Action: Issuance of Marine Protection, Research and Sanctuaries Act Section 102 permits for StarKist Samoa and VCS Samoa Packing in American Samoa.

EPA REGION IX COMMUNICATION STRATEGY

Response to Comments on Ocean Dumping Studies

This memo provides responses to comments received on the *Joint Cannery Ocean Dumping Studies in American Samoa* (CH2M HILL, June 1996). Comments were provided by Dr. Mohamed Abdelrhman from EPA's Narragansett laboratory and were received by CH2M HILL on 19 September 1996. The comments are attached to this memorandum. CH2M HILL will make appropriate changes and modifications to the report to address the comments. The changes we propose are indicated in the responses to specific comments discussed below. We will reissue a revised report after EPA reviews and approves the responses and proposed actions below. To avoid further delay, a revised report is being prepared while the responses below are being reviewed by EPA. We will issue the report as soon as possible after review of this memorandum.

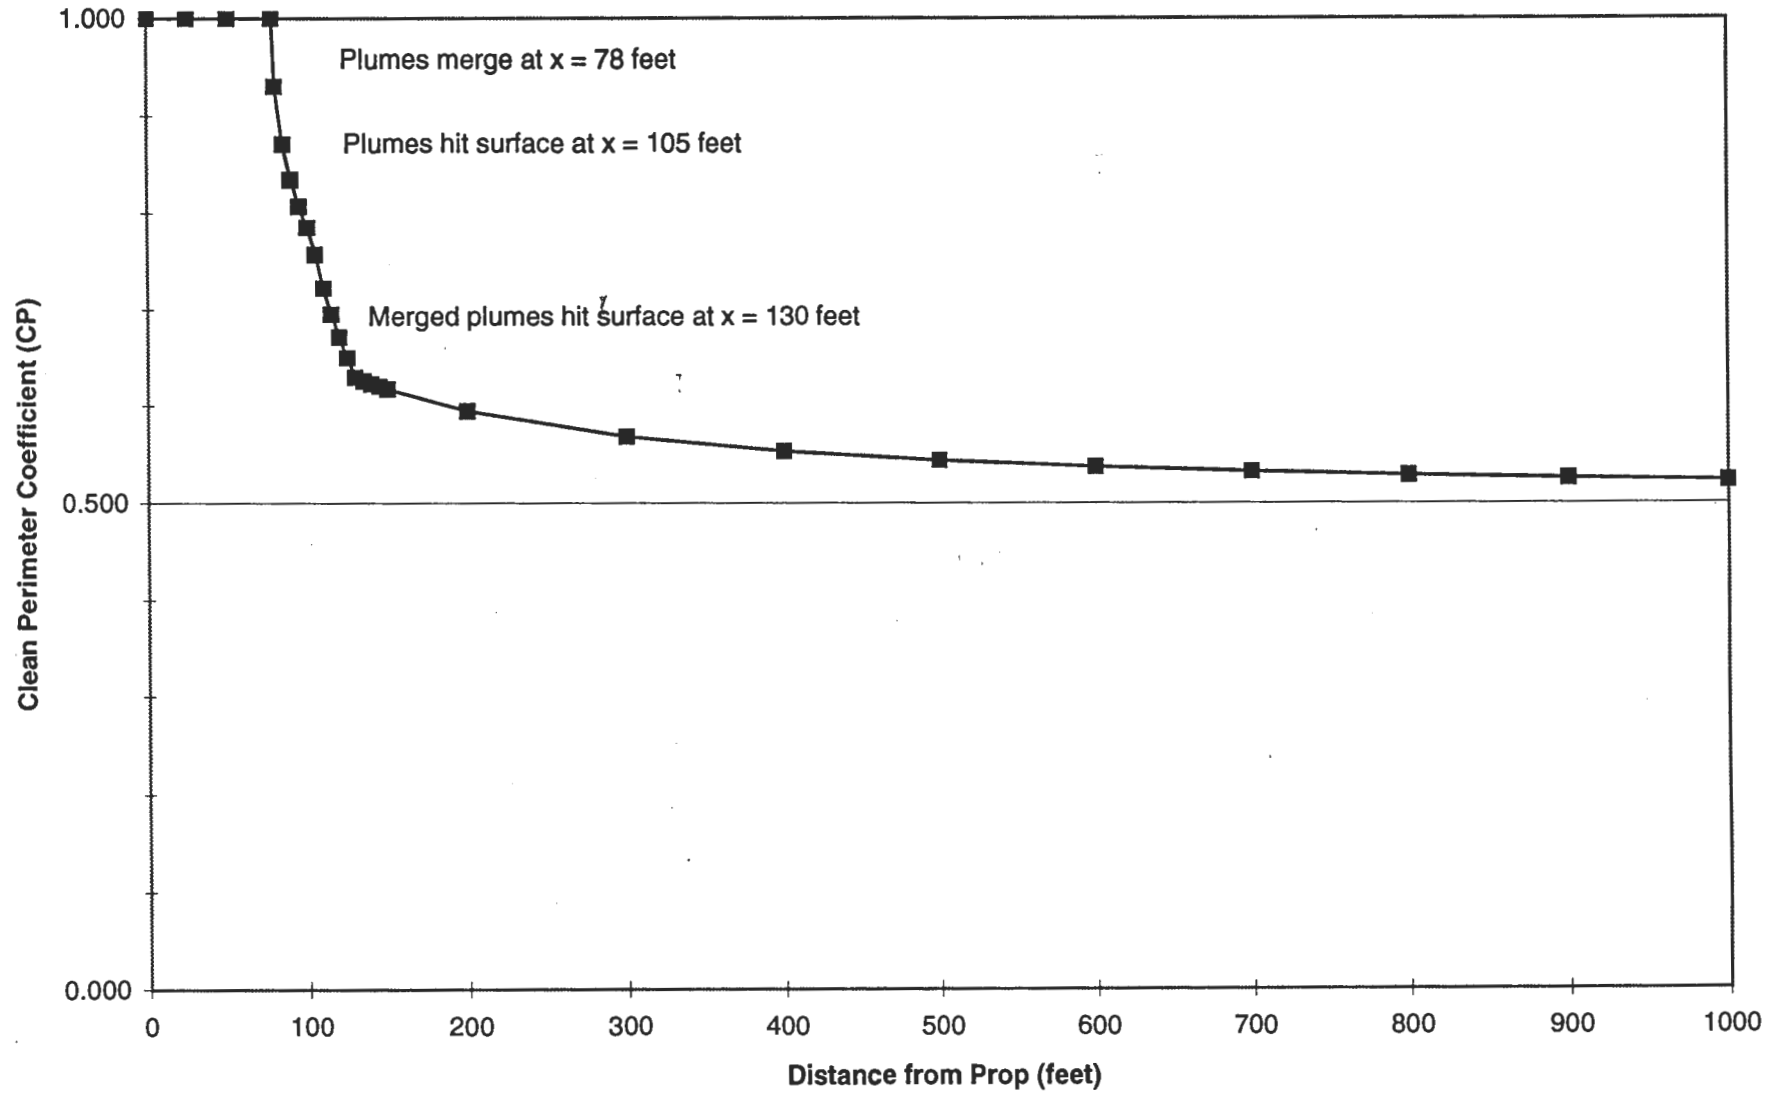
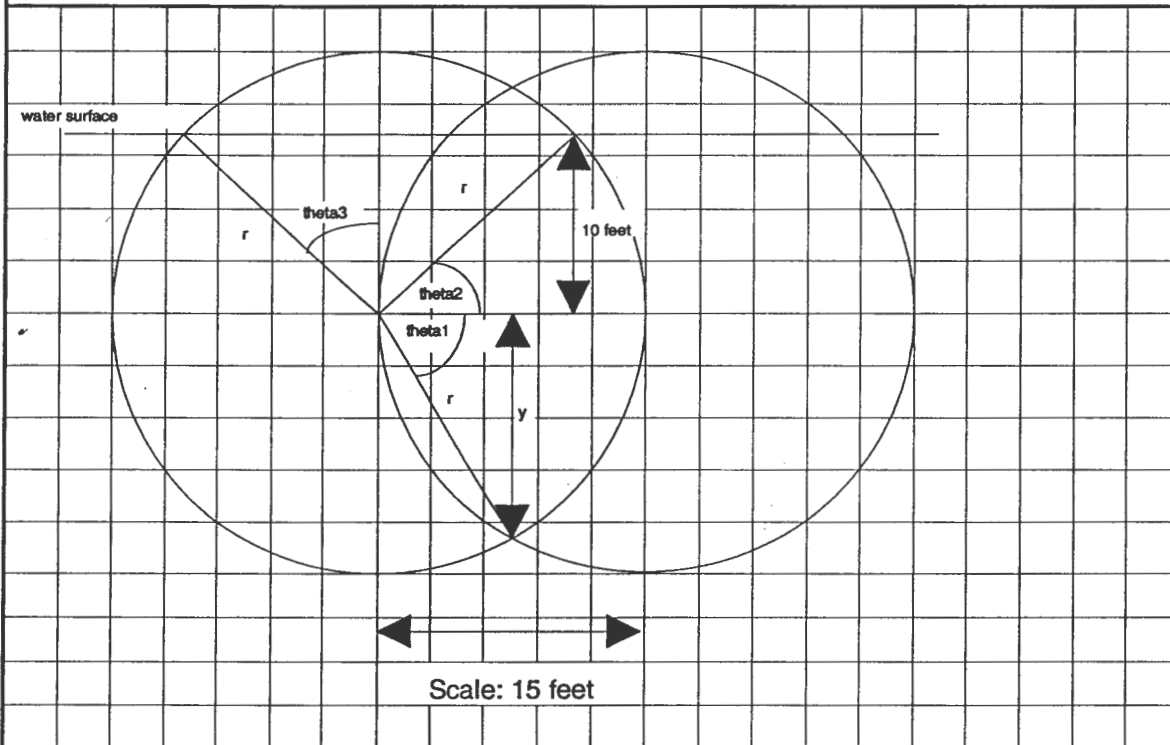
[5] The reviewer correctly states that the values of θ_2 are incorrect. It appears that a preliminary version of the output files were included in the report. To improve the presentation of this portion of the report we have reworked the calculation of the coefficient to clarify the approach and will replace the existing Appendix showing the calculation with the version attached to this memorandum. However, the results of the initial calculations as presented are correct - the newly calculated values are the same as the original for practical purposes.

The reviewer correctly interprets the physical meaning of the "clean entrainment coefficient" but considers the terminology confusing. We believe the meaning of this parameter as defined is clear, and will add text to indicate that it should not be confused with the conventional "entrainment coefficient". We feel the terminology used is adequate and descriptive - one could consider it a correction to the conventionally defined parameter and thus the terminology used in the report is appropriate. We have, however, renamed the parameter as the "clean perimeter ratio" or CP ratio as shown in the attachment to this memorandum.
